PROWatt 800/1000/1500/1750 Owner's Guide Addendum

Addendum

976-0159-01-01 Rev A

This addendum is issued to expand the Ground Fault Circuit Interrupter (GFCI) outlet features of the PROWatt series products.

Figure 1 AC Outlet with GFCI (PROWatt 1750 model shown)

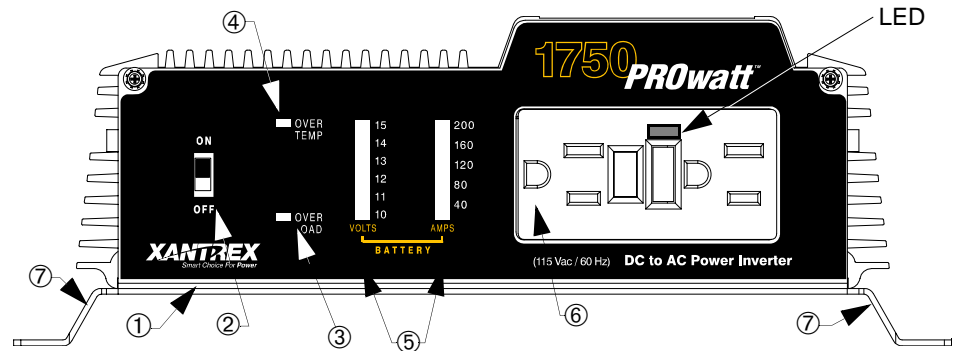
This section affects the description of the AC Outlet with Ground Fault Circuit Interrupter (GFCI) of all the above mentioned PROWatt products.

Feature	Description
⑥	AC Outlet. This is a Ground Fault Circuit Interrupter (GFCI) outlet, equipped with an LED indicator light. The LED comes on when AC power is interrupted due to a ground fault or an end of life (for the GFCI) fault. See “Troubleshooting Reference” below.
